REPLACEMENT PAGES* FOR APPENDIX A

CRYSTAL RIVER UNIT 3

TECHNICAL SPECIFICATIONS

Figure 3.7.15-1 (page 1 of 3)
Burnup versus Enrichment Curve for
Spent Fuel Storage Pool A

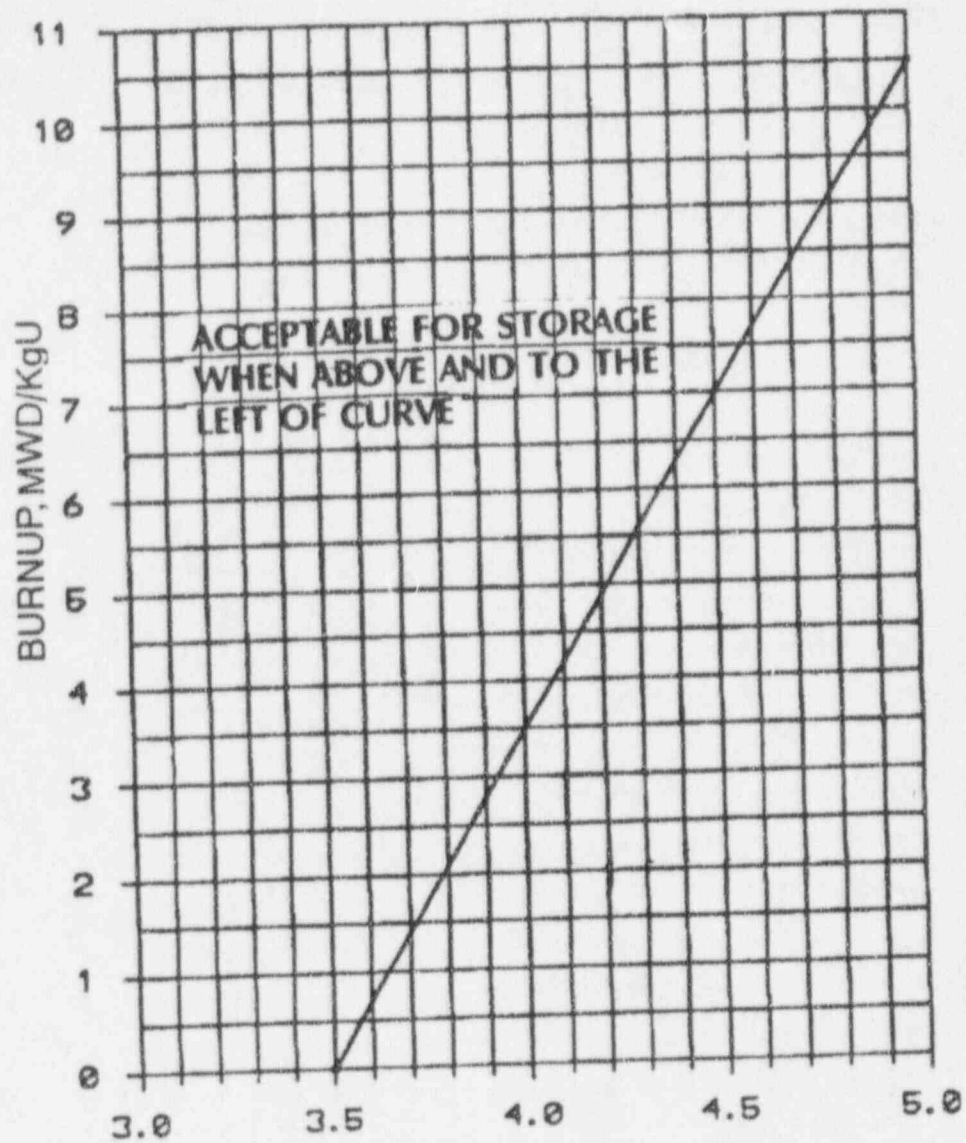
LCO 3.7.15 The combination of initial enrichment and burnup of each spent fuel assembly stored in Storage Pool A and Storage Pool B shall be within the acceptable region of Figure 3.7.15-1, Figure 3.7.15-2, Figure 3.7.15-3, or stored in accordance with the FSAR.
